Approved 11/18/82
Stayed P 32318

SEWAGE DISPOSAL SYSTEM

MARYLAND STATE DEPARTMENT OF HEALTH*

PROPERTY OWNER Edgewood Farms, Inc.

32318

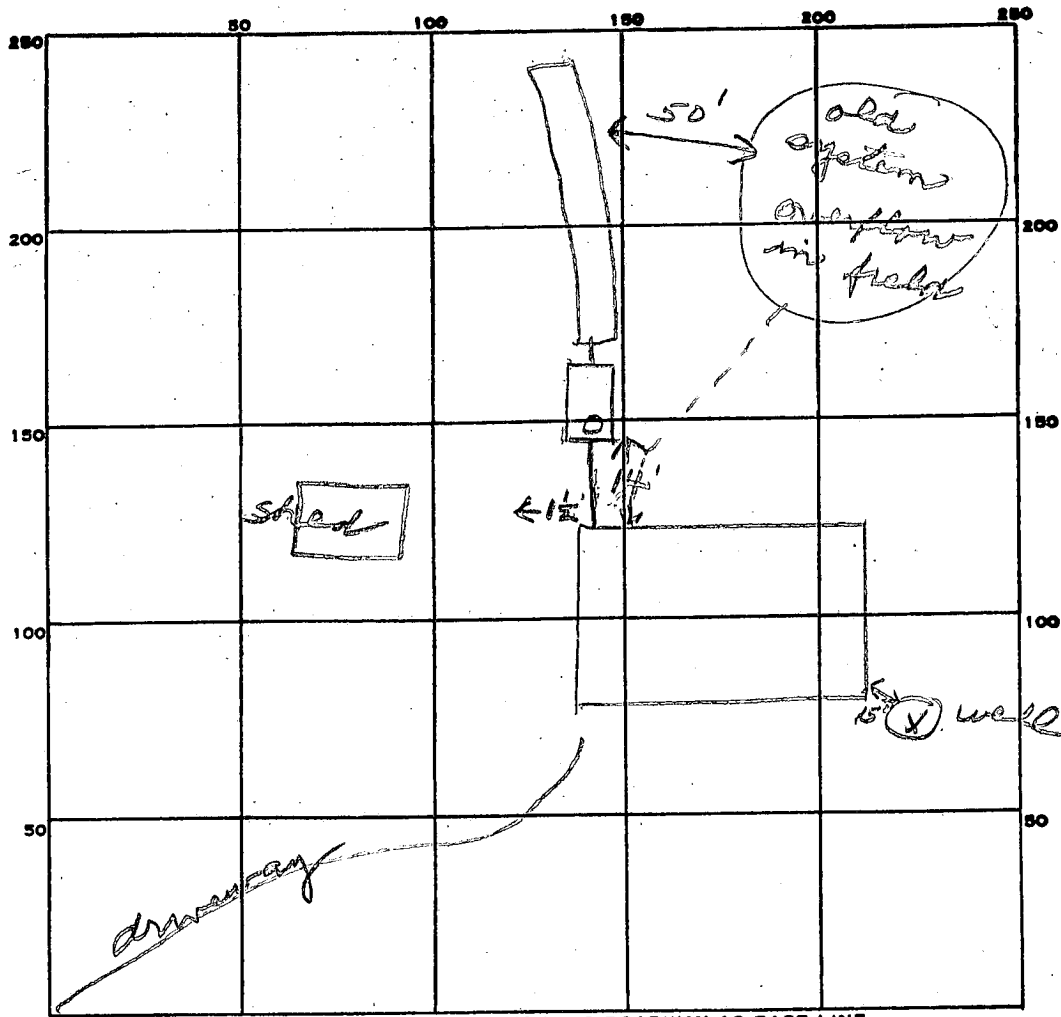
Visual hole 14 ft deep - clay at top to 3'-4' ft, then
Sand, clay loam. Water table at 5 1/2 ft. approx 15 minutes
per 2nd inch. Old system located, 3 bedroom, (see sketch)
Recommend new septic tanks with trenches at
least 6.5 ft long - 10 ft deep with 6 1/2 ft of stone
11/18/82 JS

REMARKS 11/18/82 OK to add stone in trench. JS
11/18/82 OK to cover all work. JS
